9-B-21-HZ
APPLICATION FOR CERTIFICATE OF APPROPRIATENESS

**317 E. Oklahoma Ave. 37917**
Old North Knoxville H

Original Print Date: 9/1/2021
 Knoxville/Knox County Planning -- Historic Zoning Commission

Level II Major Repair or Replacement
Porch rehabilitation project.

Rendering of **Proposed** Stair Expansion with addition of cheek walls, street angle view.

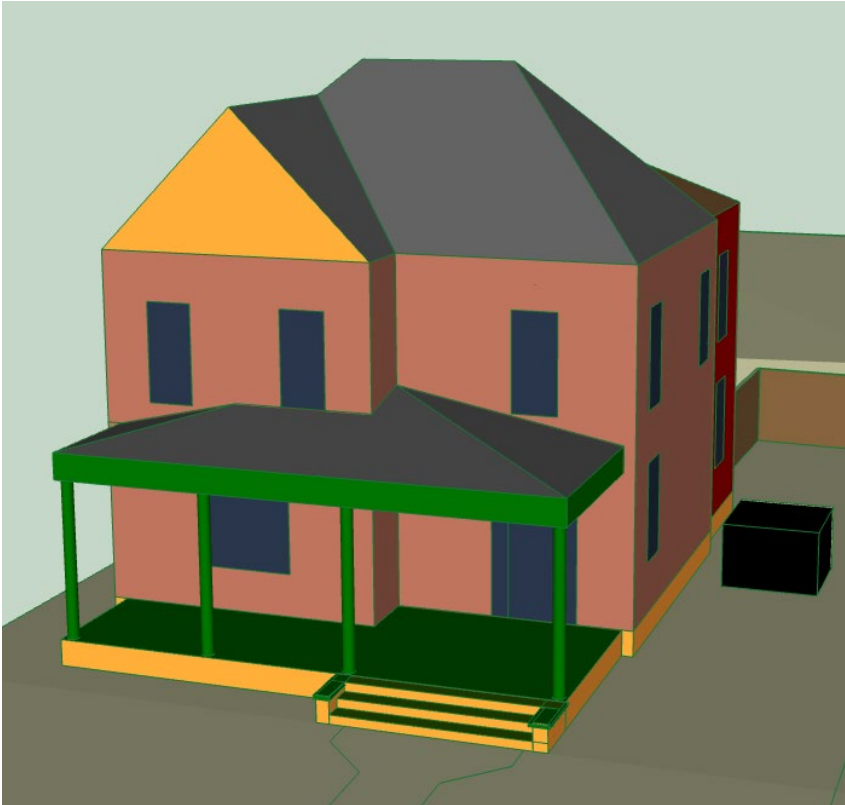
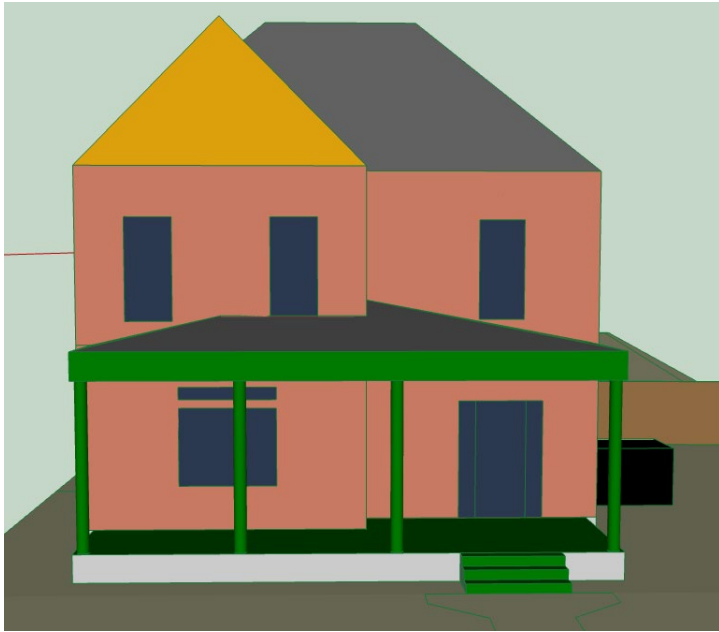
9. The handrails and wood flooring covering the concrete stairs are not original to the house and removal is appropriate. The expansion of the steps' width will make the steps more proportionate to the overall façade width. The 13" thick cheek walls are modest in design, can be seen on comparable properties throughout the district, and will not detract from the house's overall integrity.

Staff recommends approval of the work as submitted, with the condition that applicant submit final specifications for column replacements (including capitals and bases, as necessary) to staff to ensure the new elements reflect existing in size, design, texture, and finish.

Example dimensions for proposed columns, specific size highlighted.

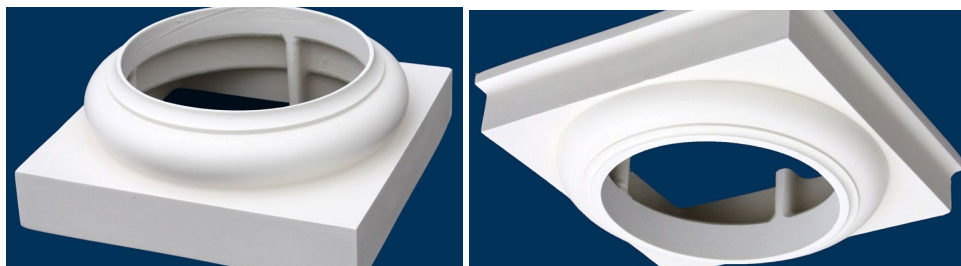
8. The applicant has provided several possible manufacturers and measurements of the existing columns; final selection of the column replacements (along with capitals and bases) should be submitted to staff to ensure the new elements reflect the existing in size, design, surface texture, and finish.
